Madison and Gunderson Place  
435 Madison Street  
Oak Park, Illinois 60302

## **PD Application - amended Item 1**

### **NARRATIVE - revised 2/27/20**

***Traffic Impact Study Summary Brief  
Proposed Apartments  
435 W. Madison Street – Oak Park, Illinois***

1 FIRST FLOOR PLAN  
SCALE: 1/16" = 1'-0"

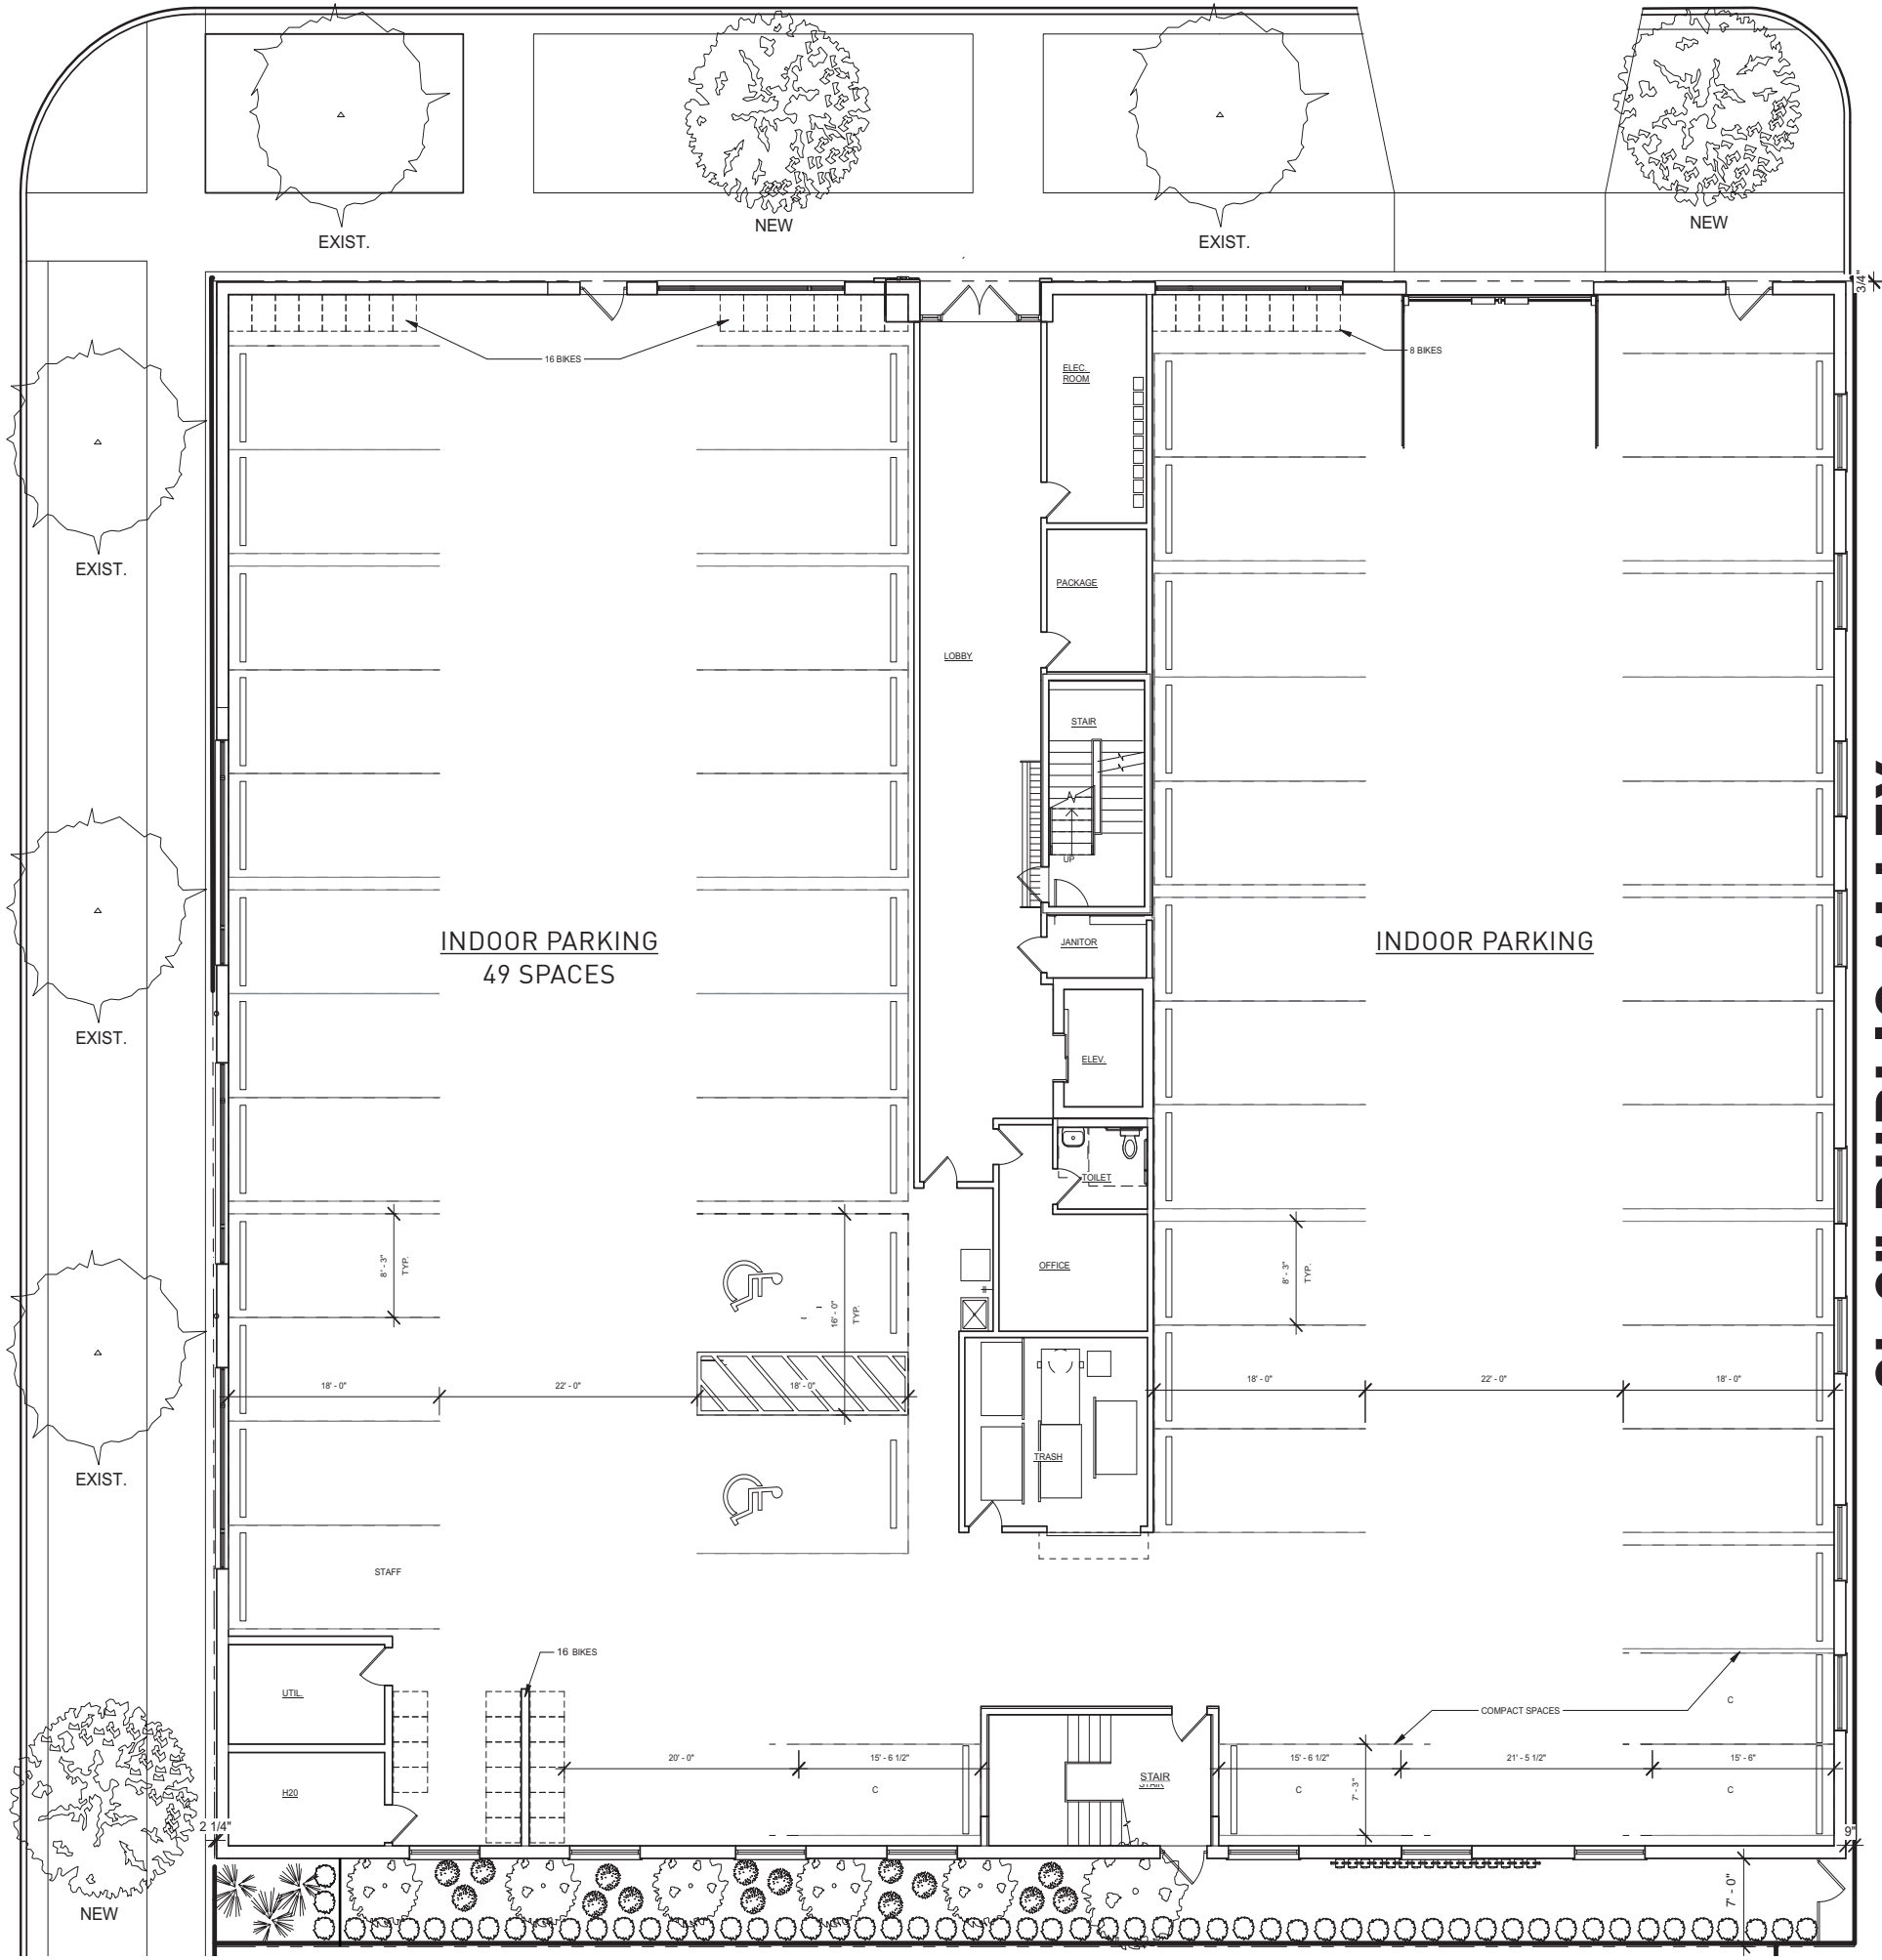
1. Redesign of the proposed building  
See the revised architectural plans, elevations and rendering.
2. Vehicle entrance moved to Madison Street  
See the revised site plan and landscaping plan.
3. Building massing refinements at the South building façade  
See the revised rendering and elevations.
4. Addition of green space and landscaping  
See the revised Landscaping Plan.
5. Additional traffic counts and Parking Studies  
See the revised Traffic Study and Parking Recommendations.
6. Addition of a building mural at street level  
See the revised rendering.
7. Correction to the Market Analysis Report  
See the Letter by HollyAnn Eageny from Tracy Cross and Associates.

**Topic #2.** Access to the apartment building garage should be on Madison Street and not Gunderson Avenue.

**Response:** Access to the apartment building garage has indeed been moved to Madison Street. This relocation will help ensure that the site traffic impacts will be isolated along Madison Street and will not burden the neighborhood streets. Its location is approximately the same as the existing garage at the east end of the commercial building. Site traffic has been reassigned and the capacity analyses redone (see **Exhibits 6, 7, and 8**) in the updated TIS.
